**RE: 116 Vallecitas Way**

I reviewed the drawings, and evaluated the site context. My comments and recommendations are as follows:

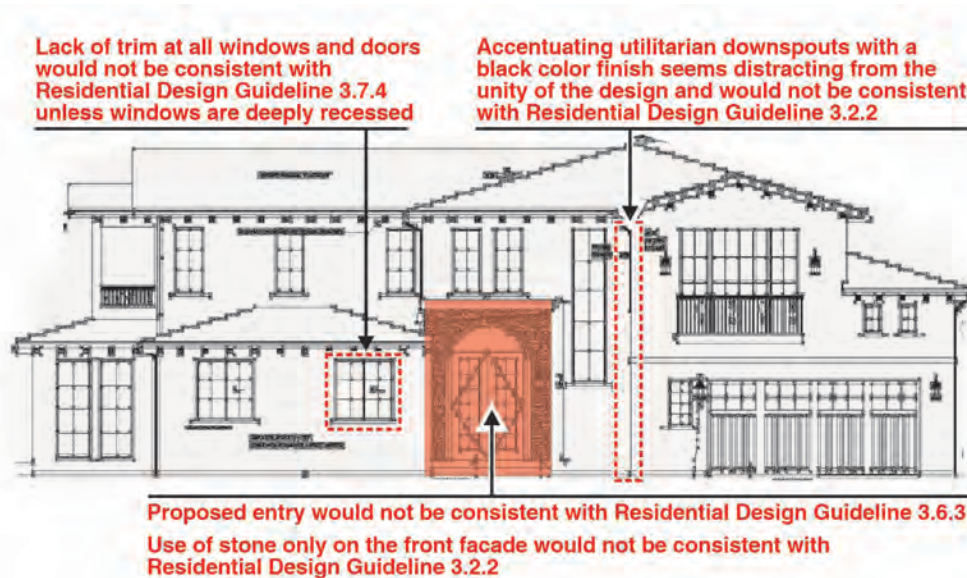
2. The form and materials of the proposed projecting entry would not be consistent with Residential Design Guideline 3.6.3.

- *Avoid large and formal entries unless that is the norm for nearby houses. It is often best to start the design consideration with an entry type (e.g., projecting or under eave porch) that is similar to nearby homes).*

2. Simplify the entry form and details, and add shed roof to match the main roofs.
3. Eliminate the stone on the front facade entry.
4. Substantially recess all windows and doors to be consistent with Residential Design Guideline 3.7.4, and ensure that the divided pain windows meet the criteria of that guideline.
5. Subdue the downspouts prominence to better blend with the wall color.

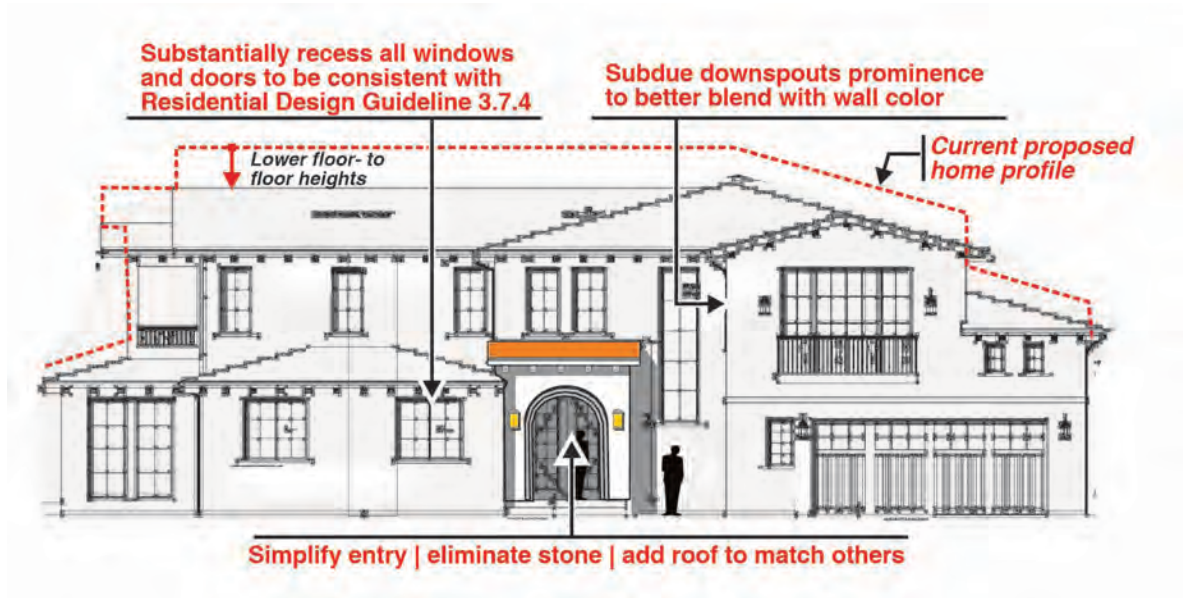
4. The lack of trim around all windows and doors would not be consistent with Residential Design Guideline 3.7.4 unless the windows are deeply recessed from the exterior wall surface.

- *Most architectural styles - except Mission, Spanish Eclectic or Modern - should have wood trim around the windows. The trim width should be matched to the style, but in general, should not be less than 3 1/2 inches wide. Head trim depth should be equal to or wider than the jamb casing, but not less than one-sixth of the opening width.*

- *Projecting window sills and heads are strongly encouraged unless the architectural style would not normally have those features.*
- *Wood trim is also encouraged on stucco houses unless the window frames are recessed at least 6 inches from the outside face of the wall. The use of stucco covered foam trim is strongly discouraged.*

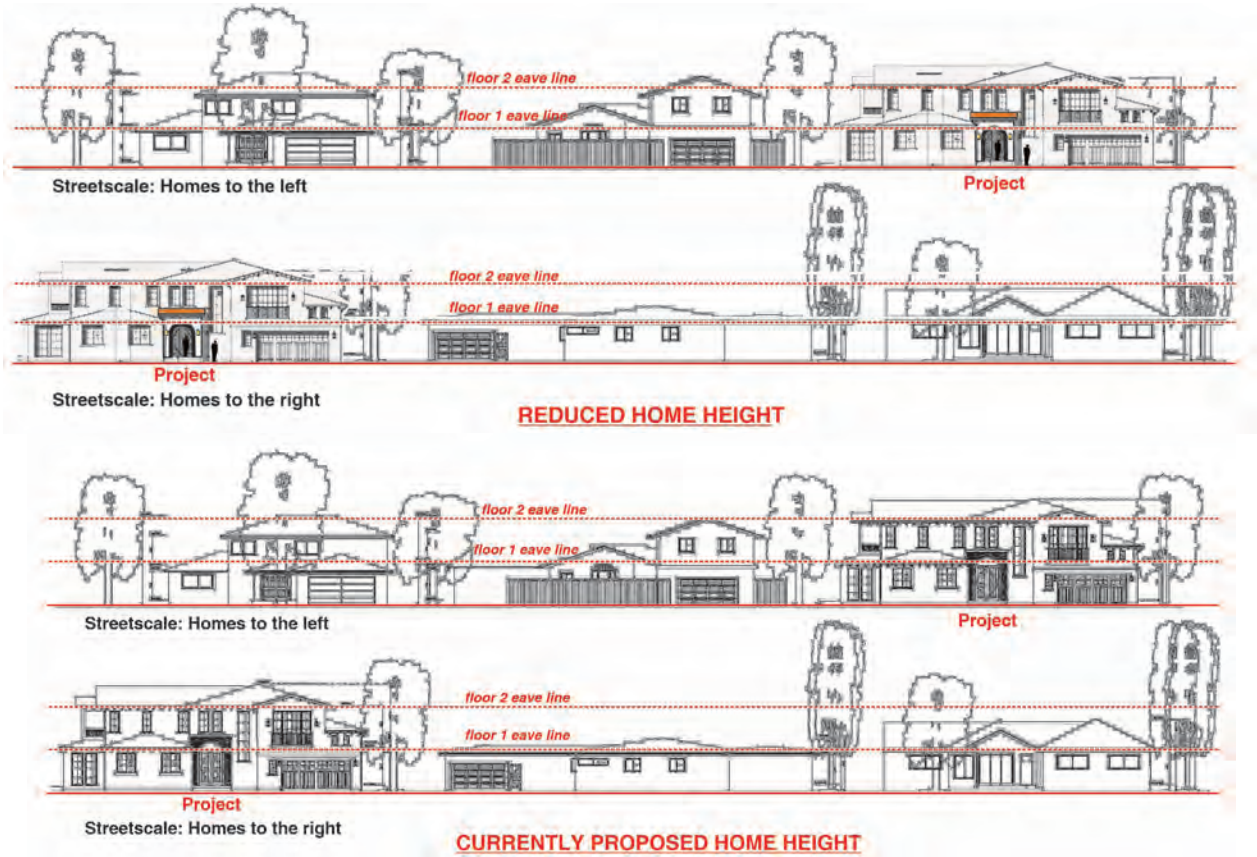
1. The ten foot floor-to-ceiling heights on both floors of the house would make it substantially taller than other homes in the immediate neighborhood and would not be consistent with Residential Design Guideline 3.3.2. This would be accentuated by the fact that the second floor is much larger than other nearby two story homes. - see streetscape elevations below.

1. Lower the floor-to-ceiling heights to reduce the structure's height to be more compatible with the other homes in the immediate neighborhood - see streetscape comparison illustrations below.
